# UNITED STATES PATENT AND TRADEMARK OFFICE

10/721,474

**Office Action Summary**

### **DETAILED ACTION**

**Fig. 4**

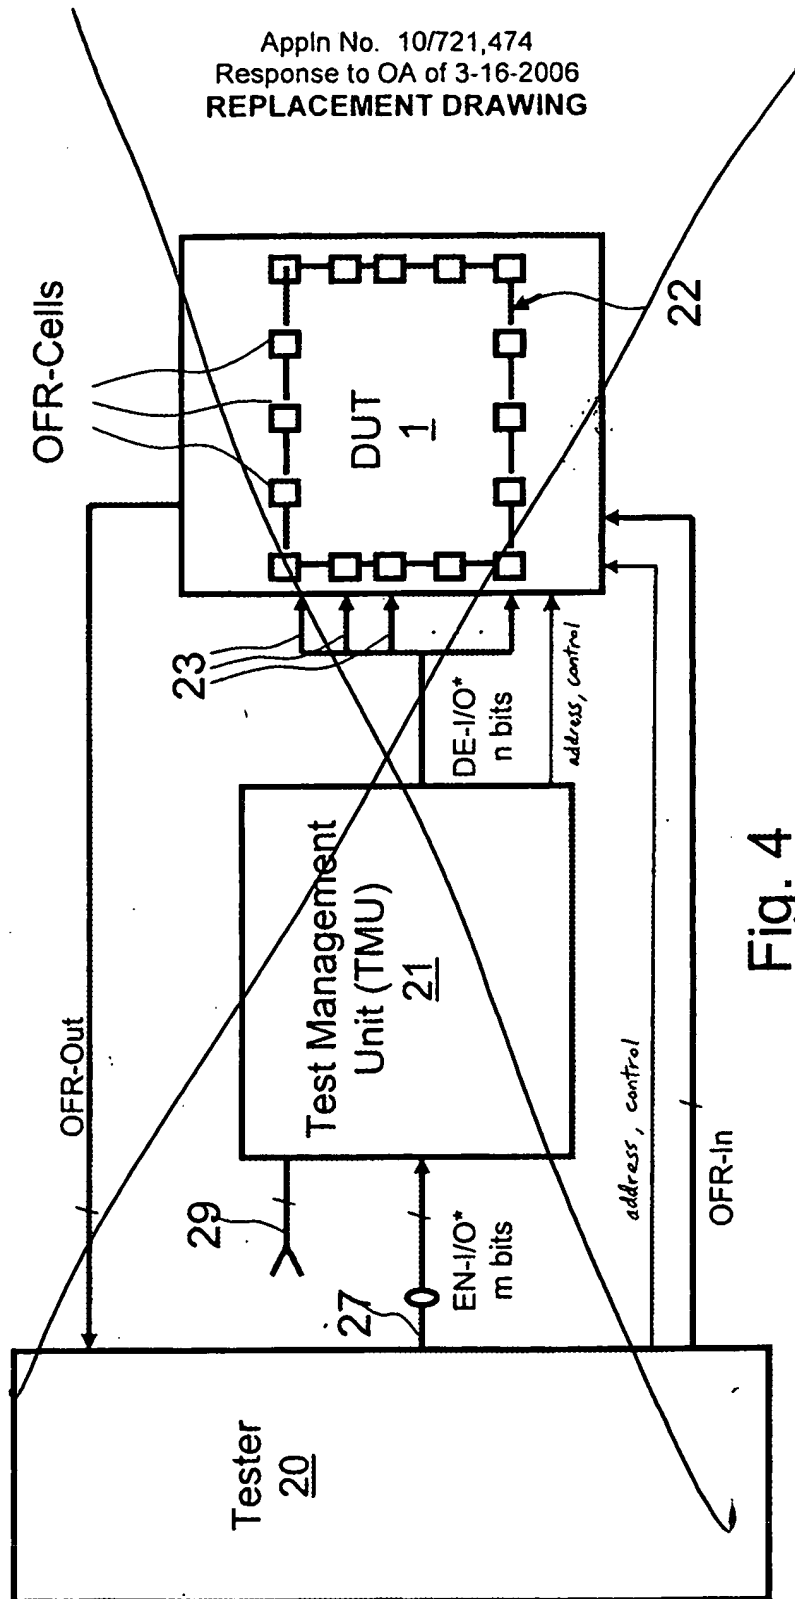
2. The examiner disapproves of the entry of said new FIG. 4, and maintains the objection of the previous office action in paragraph 2 because the applicant has not provided support for the features of claims 13 and 14 which were objected to because the drawings do not show the feature wherein the device under test takes test address signals directly from the tester.

As per paragraph [23], there is no reference or teaching of a direct connection of the address signals between the Tester 20 and the DUT 1 in regard to FIG. 4, therefore the amendment to paragraph [23] is disapproved.

reference to, or teaching of, a direct connection of the address signals between the Tester 20 and the DUT 1 of FIG. 4.

9. The amendment to FIG. 4, submitted by the applicant in response to the objection in the previous office action, paragraph 2, is objected to because it introduces new matter. 35 U.S.C. 132(a) states that no amendment shall introduce new matter into the disclosure of the invention. The added material which is not supported by the original disclosure is as follows: There is no reference to or teaching of a direct connection of the address signals between the Tester 20 and the DUT 1 of new FIG. 4.

Applicant is required to cancel the new matter of this drawing in the reply to this Office Action.

*Entry not approved 9/6/06 TJS*

Fig. 11

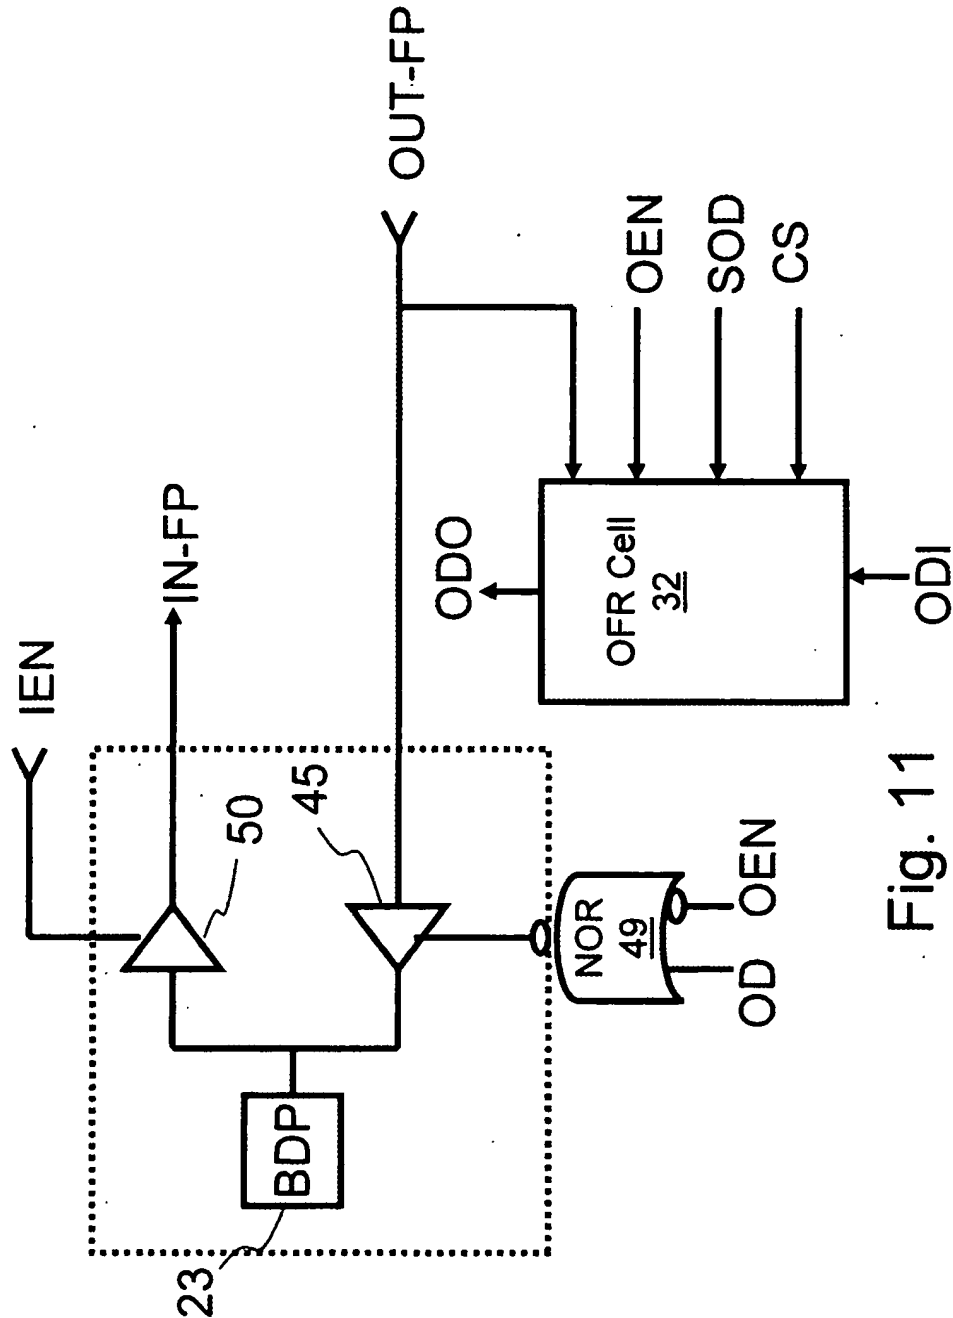
1. In view of the changes to FIG. 11 and 12, and new drawing FIG. 13, the examiner withdraws the objections in the previous office action, paragraphs 1 and 3.

The examiner also approves the entry of new FIG.s 11, 12 and 13 presented in the applicant's amendment.

Entry approved. 9/6/06 *PA*

Fig. 12

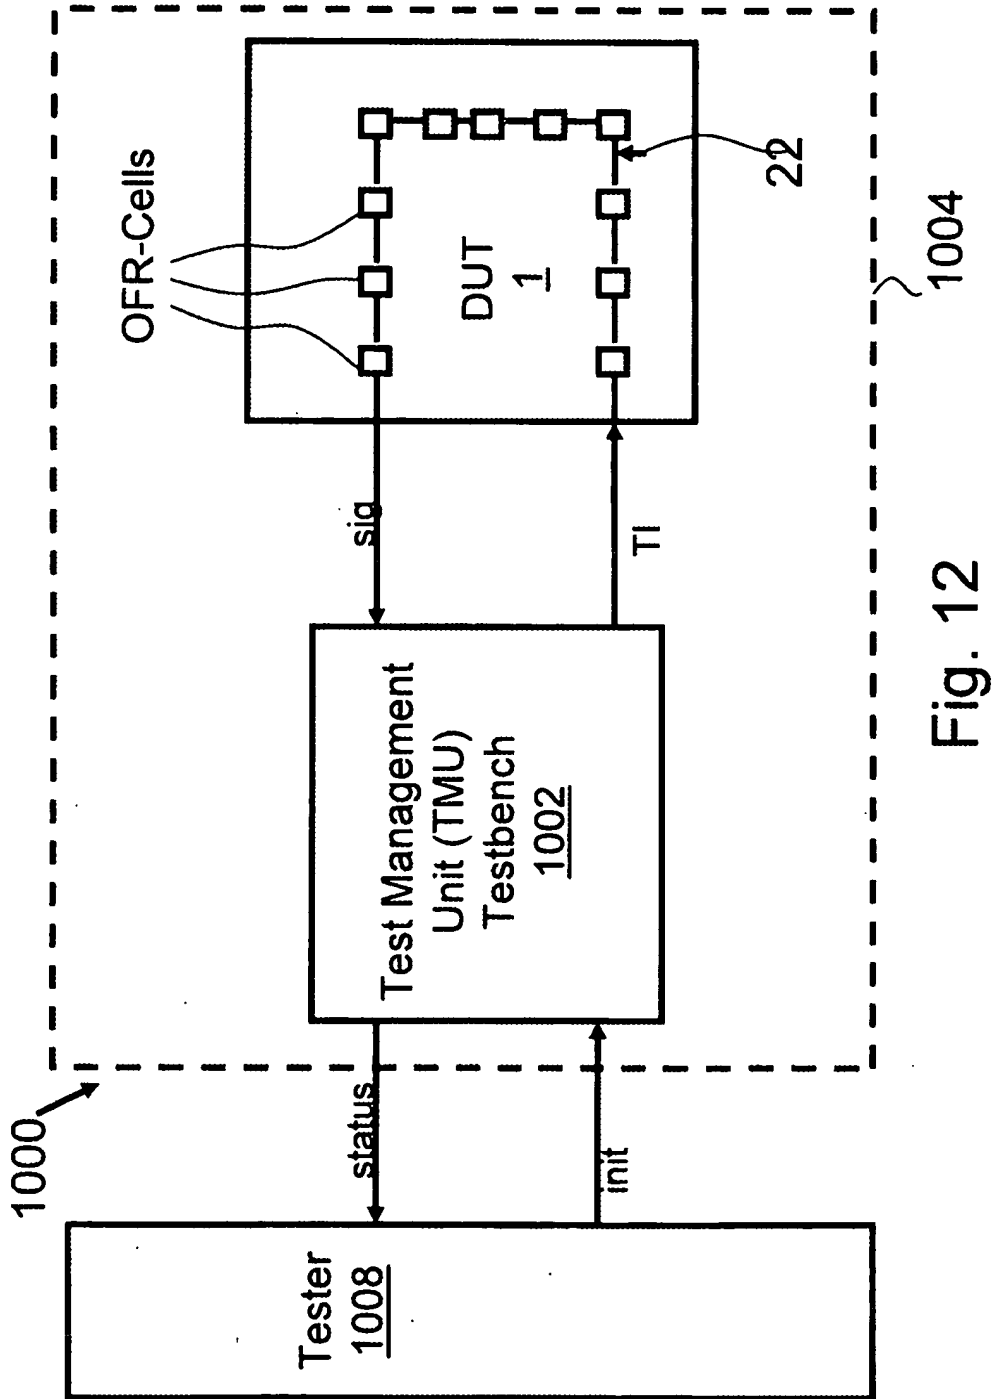
Entry approved. 9/6/06 *mt*

FIG. 13

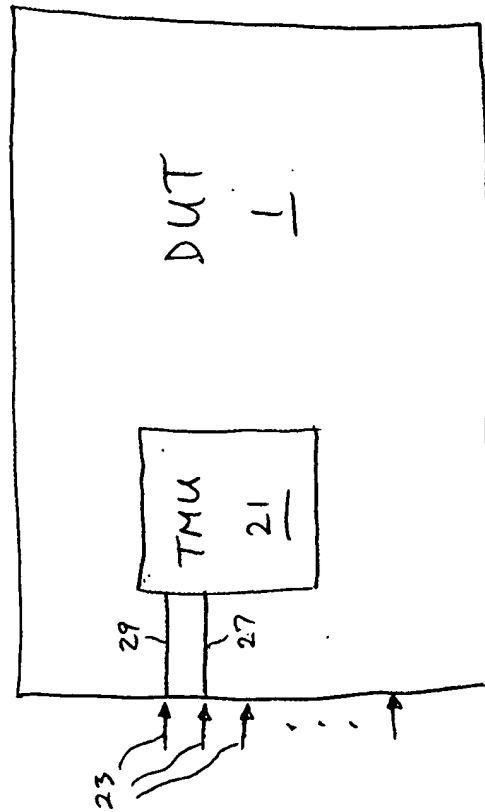
Entry approved, 9/6/06 MJ
